<u> </u>						
	Application No.	Applicant(s)				
	10/807,055	KING, PETER J.				
Office Action Summary	Examiner	Art Unit				
	Christopher H. Orders	3746				
The MAILING DATE of this communication a Period for Reply	ppears on the cover sheet with the c	orrespondence address				
A SHORTENED STATUTORY PERIOD FOR REP THE MAILING DATE OF THIS COMMUNICATION - Extensions of time may be available under the provisions of 37 CFR after SIX (6) MONTHS from the mailing date of this communication. - If the period for reply specified above is less than thirty (30) days, a relative to reply within the set or extended period for reply will, by state Any reply received by the Office later than three months after the mail earned patent term adjustment. See 37 CFR 1.704(b).	1. 1.136(a). In no event, however, may a reply be tireply within the statutory minimum of thirty (30) day of will apply and will expire SIX (6) MONTHS from the cause the application to become ABANDONE	nely filed s will be considered timely. the mailing date of this communication. D (35 U.S.C. § 133).

DETAILED ACTION

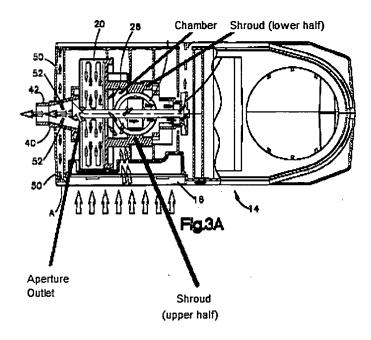
DeYoung et al. teach a method of providing a cooled blower unit, comprising the steps of: rotating a feed air impeller (22, 24) in a casing (enclosing chamber 20), said casing (enclosing chamber 20) having a casing inlet (26) and at least one aperture outlet (see annotated figure 3a below); rotating a cooling air impeller (60) at a rear of a motor (10) and said feed air impeller (22, 24) at a front thereof; providing a shroud (see annotated figure 3a below) having a chamber (see annotated diagram below) adjacent said casing (enclosing chamber 20), said motor (10) being retained in said shroud (see annotated figure 3a below), providing at least one passage from said chamber (see annotated figure 3a below) to a shroud outlet (the left most portion of the shroud) in said shroud (see annotated figure 3a below); retaining said shroud (see annotated figure 3a below) in a housing (14), forming at least one air opening (16) and a housing outlet

(through which 40 extends) in said housing (14), said housing outlet (through which 40 extends) receiving said shroud outlet (the left most portion of the shroud); rotating said cooling air impeller (60) to draw inlet air through said at least one air opening (16), said inlet air flowing between said motor (10) and said shroud (see annotated figure 3a below), said inlet air flowing out of said shroud (see annotated figure 3a below) and said housing (14); and rotating said feed air impeller (22, 24) to draw said inlet air between said shroud (see annotated figure 3a below) and said housing (14) into said casing inlet (26) (see flow arrows, fig. 3a), said feed air impeller (22, 24) forcing air through said at least one aperture outlet (see annotated figure 3a below) to said housing outlet (through which 40 extends); providing said housing (14) with a first housing half (fig. 2) and a second housing (14) half (fig. 3b), said at least one air opening (16) and said housing outlet (through which 40 extends) being formed in a front of said first housing (14) half (fig. 2) (both are in the front portion [to the left] of the casing as viewed from fig. 2, and the housing outlet is shared between both the first and second casing halves as seen in fig. 3a and 3c); forming a recess (68) in a bottom of said second housing (14) half (fig. 3b) (when viewing the apparatus such that the second casing half is the bottom); providing said shroud (see annotated figure 3a below) with a lower shroud half (see annotated figure 3a below) and an upper shroud half (see annotated figure 3a below), forming a discharge passage (the right most portion of the shroud has a discharge passage shared between both halves) in said lower shroud half (see annotated figure 3a below), said discharge passage (the right most portion of the shroud has a discharge passage shared between both halves) communicating with said recess (68) to exhaust

said inlet air from between said motor (10) and said shroud (see annotated figure 3a below) (see flow path arrows, fig. 3a); attaching a portion of said casing (enclosing chamber 20) to said motor (10) (fig. 1); rotating said feed air impeller (22, 24) in said casing (enclosing chamber 20) to form an air compressor.
